PREVOST

**WARRANTY
BULLETIN**

Wb08-02A

DATE : APRIL 2008	SECTION : 06 - ELECTRICAL
EXPIRATION: APRIL 2010	
SUBJECT : POWER WINDOW HARNESS – REMOVAL OF ZENER SUPPRESSOR DIODES

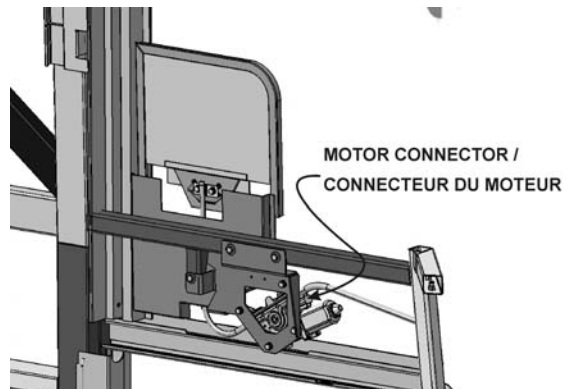
1. Open the front electrical and service compartment.
2. Remove the plastic panel protecting the electrical components.
3. Locate the power window electrical harness. You will find it over the electrical compartment, within the area shown on the image at right.

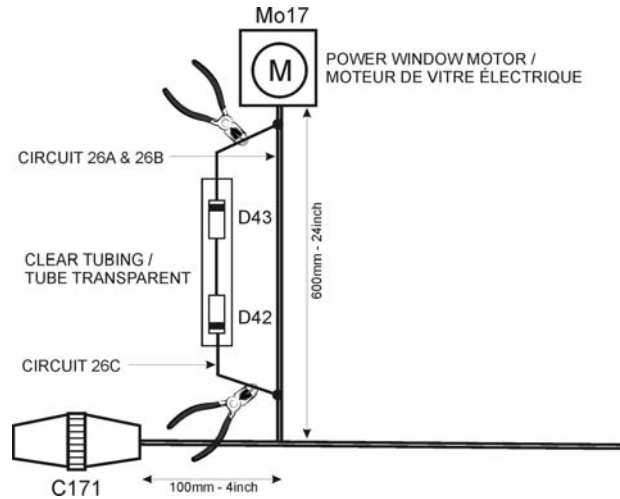
4. Starting from the motor connector, find the diodes along the harness.

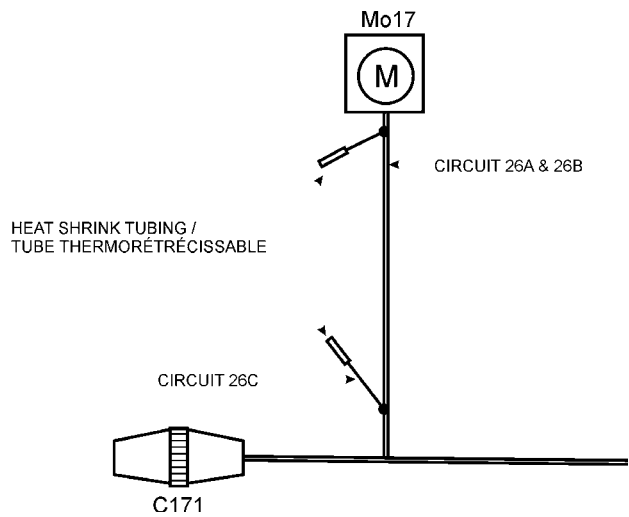
- Diodes D42 & D43 are placed inside clear protective tubing. Cut circuit 26C before and after the clear tubing.

- Place heat shrink tubing on the remaining circuit.
- Restore electrical power on the vehicle and test the functioning of the power window.

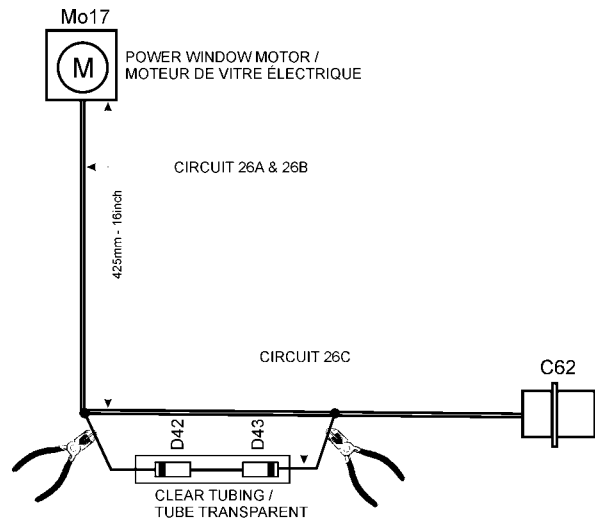
4. Starting from the motor connector, find the diodes along the harness. Diodes are located at about 16" from the connector.
5. Diodes D42 & D43 are placed inside clear protective tubing. Cut circuit 26C before and after the clear tubing.

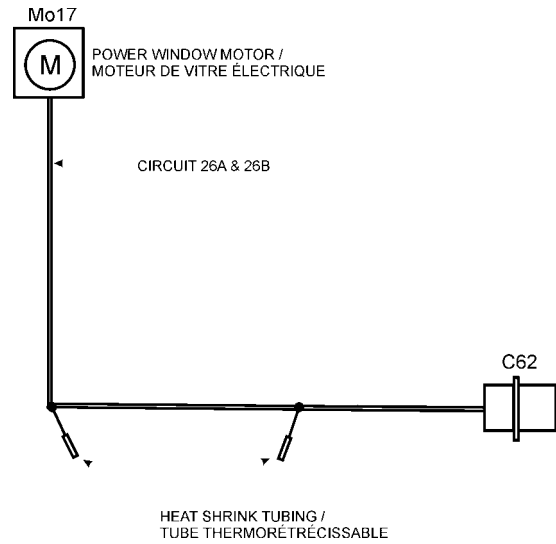
6. Place heat shrink tubing on the remaining circuit.
7. Restore electrical power on the vehicle and test the functioning of the power window.

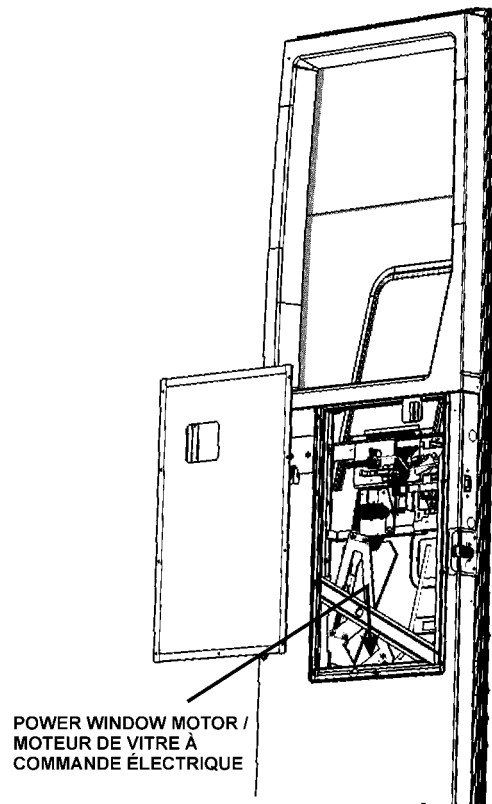
8. On XLII series vehicles, the entrance door power window harness must also be corrected.
9. In order to get to the power window motor, remove the door interior finishing and the access panel. Cut through the insulating layer to gain access to the power window motor electrical harness. The harness will be found along the oblique square tube shown on the image at right.

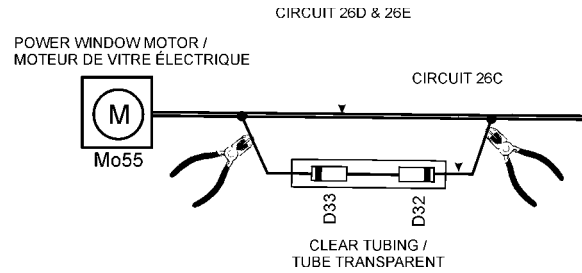
10. Starting from the motor connector, find the diodes along the harness. Diodes are located at about 7" (175mm) from the connector.
11. Diodes D32 & D33 are placed inside clear protective tubing. Cut circuit 26C before and after the clear tubing.

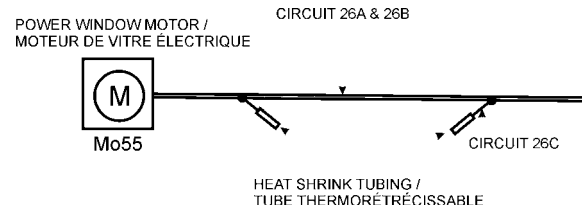
12. Place heat shrink tubing on the remaining circuit.
13. Restore electrical power on the vehicle and test the functioning of the power window.
